TOWER CROSSING RETAIL - PHASE II

MCC RETAIL SUBDIVISION FILING NO. 3

TITLE: INFRASTRUCTURE SITE PLAN
DATE: 01.16.2024

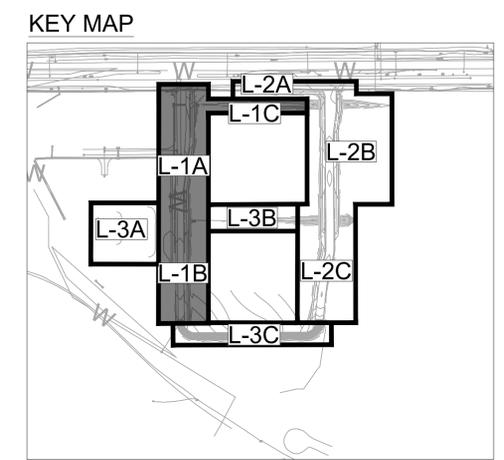
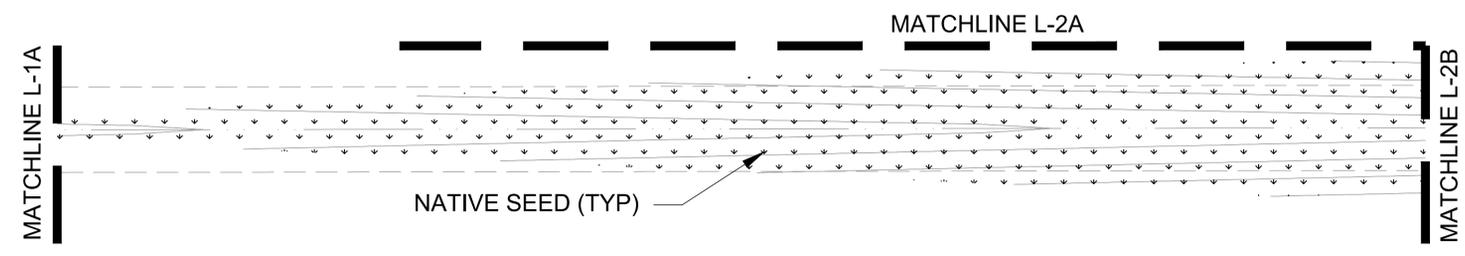
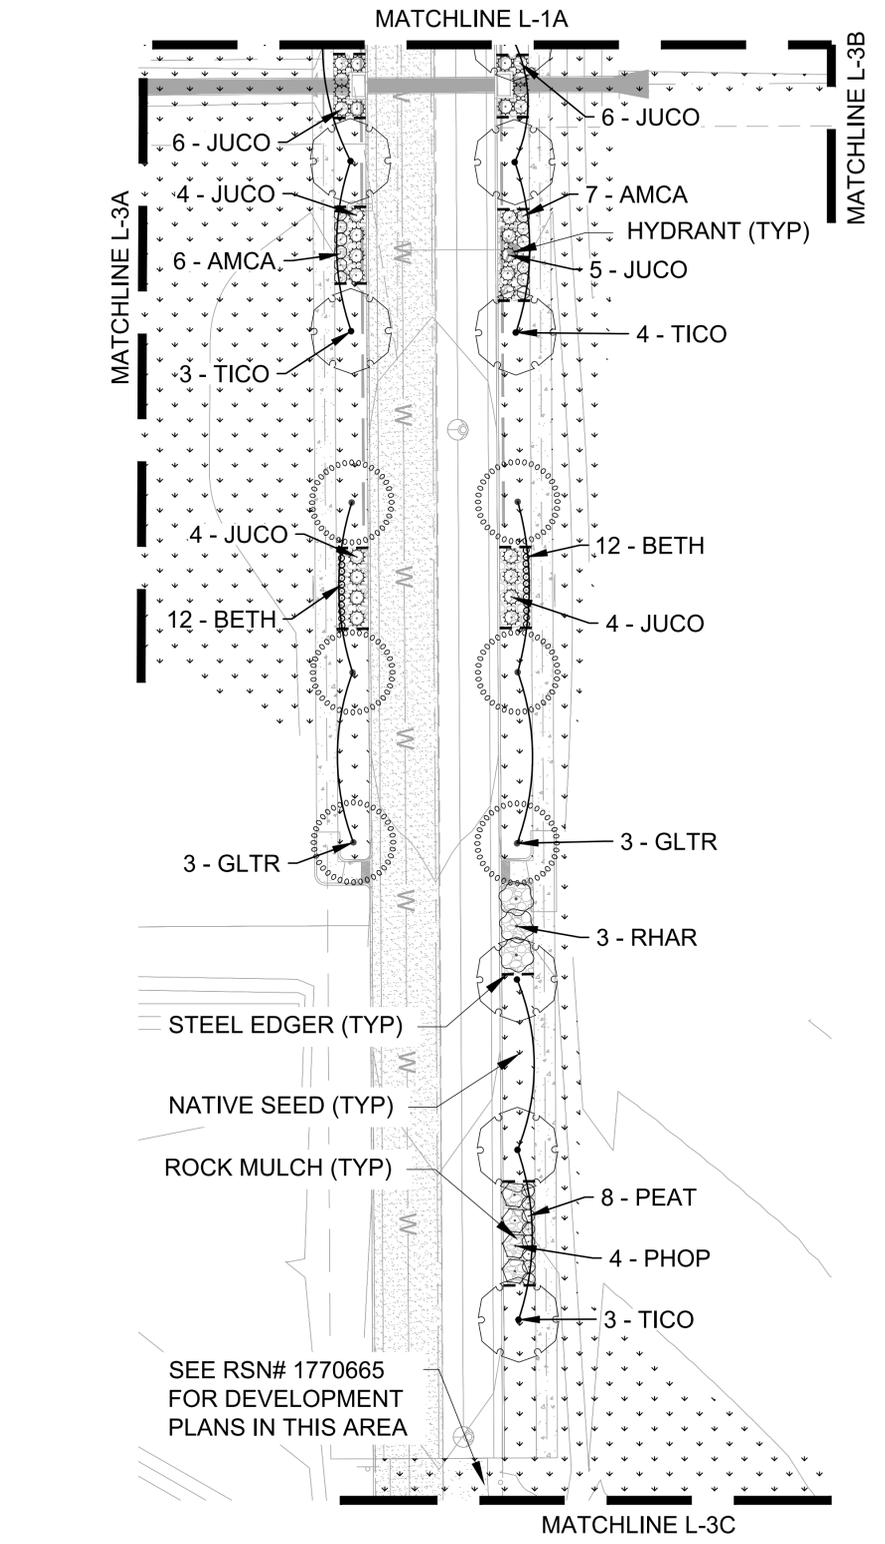
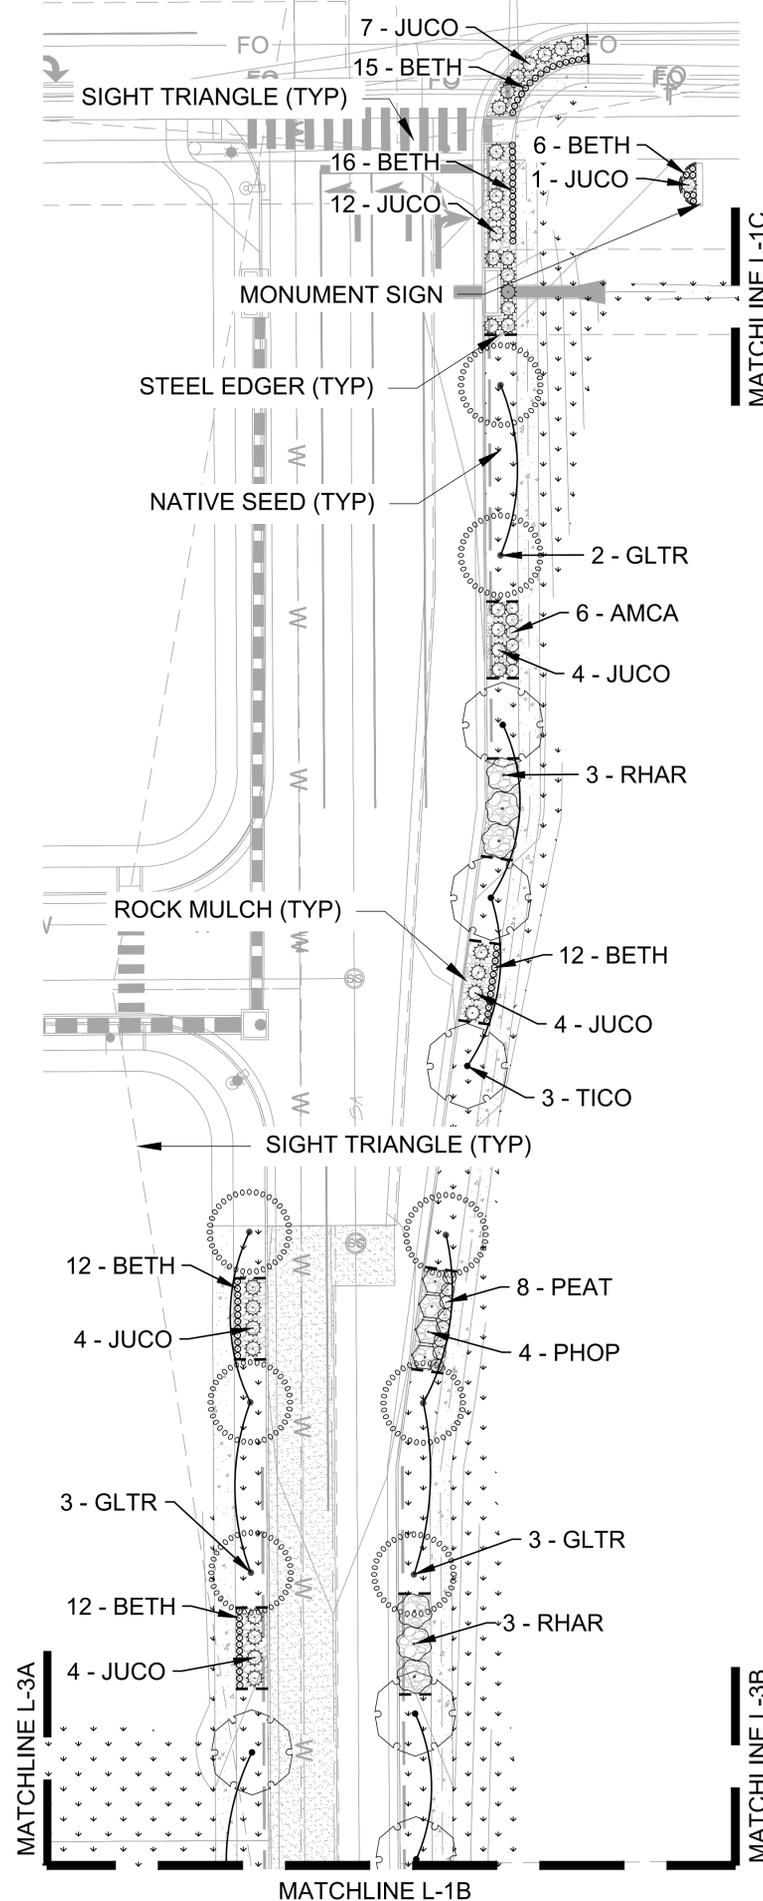
From civil plan review: Why is this turn lane proposed? There is not a proposed access on the north side for this turn lane.

Where is this taper rate from?

PER CONVERSATION WITH COA, IT WAS DECIDED THAT A 156' TAPER WOULD BE REQUIRED FOR THE LEFT TURN LANES. THE PLANS HAVE BEEN REVISED ACCORDINGLY.

Okay to use

PER CONVERSATION WITH COA, IT WAS DECIDED THAT A 164' TAPER WOULD BE REQUIRED FOR THE RIGHT TURN LANE. THE PLANS HAVE BEEN UPDATED ACCORDINGLY.
